UNITED STATES PATENT AND TRADEMARK OFFICE

Office Action Summary

10/694,749

DETORO ET AL.

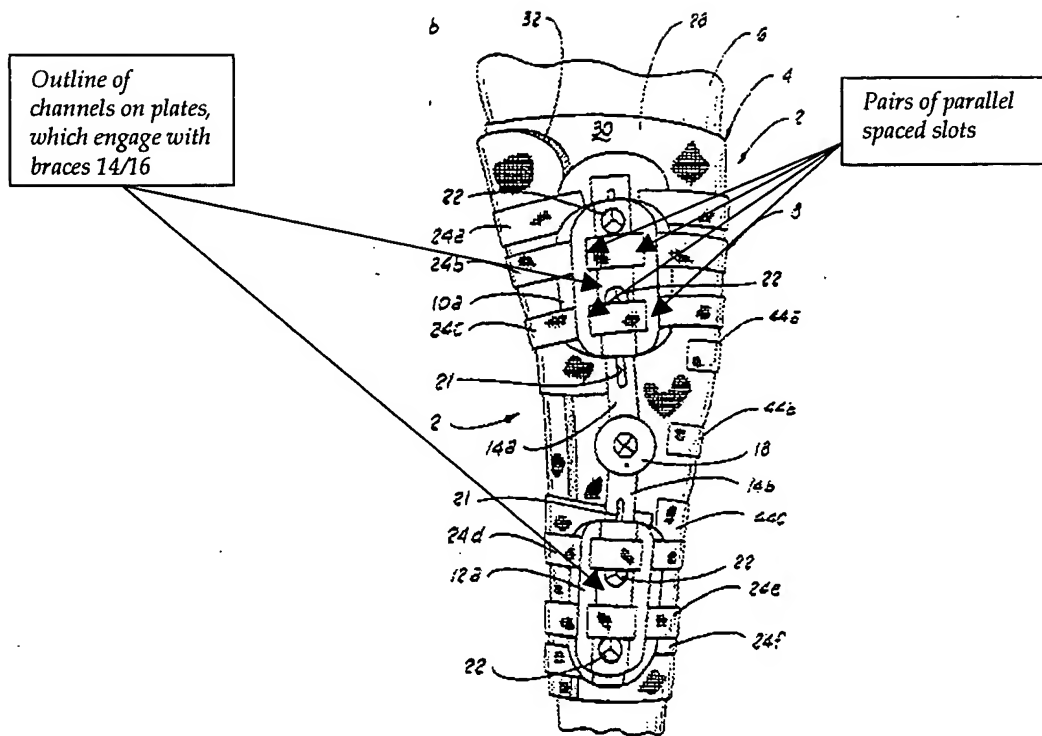
Regarding claim 5, the means for adjustably securing said knee immobilization brace to the wearer's leg comprises a plurality of straps (24a-c) adjustably extending from multiple strap mounting slots (see column 3, lines 49-54 and Figure below) in said respective upper and lower leg engagement portions, and strap to strap interengagement means (26) thereon. Regarding

claim 10, the strap mounting slots further comprise oppositely disposed pairs of parallel spaced slots in longitudinally spaced relation (see Figure below) on said respective upper and lower leg engagement plates.

Regarding claim 6, the upper and lower leg engagement plates are transversely contoured to registerably engage the wearer's leg (see plates engaged against leg in Figures 1 and 2), and a mounting channel (see outlines of channel in Figure 2 below) is defined in each of said upper and lower leg engagement plates, wherein the channel of the leg engagement plates cooperates with the vertical braces (14/16) to allow vertical movement of the leg engagement plates along the braces.
